**AIA**[®]**Document G731[™] – 2019****Change Order, Construction Manager as Adviser Edition****PROJECT: (name and address)**

Christian County High School

Change Order Number: 094

PROPOSAL REQUEST

- **Four-Sided Full Color LED True Pixel Video Display**
6.56'H x 8.20'W 3.9mm (512 x ? pixel matrix)
- **Custom Imprinted Wedge Panel (4)**
- **Custom Imprinted Bottom**

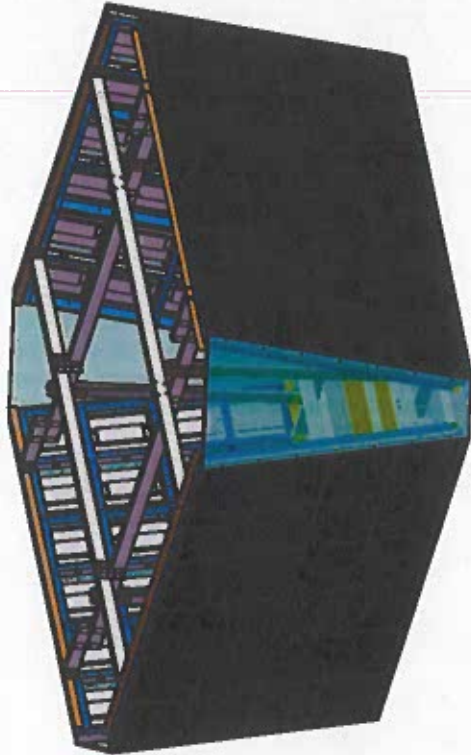
- 1) Provide four-sided video scoreboard Nevco 69886B in lieu of originally specified scoreboard. Include corner piece and underside graphics in bid in main gymnasium.
- 2) Provide all accessories and supports and misc. materials as req'd to hang scoreboard from structure.
- 3) Provide all controls, wiring and accessories to provide a fully operational scoreboard.
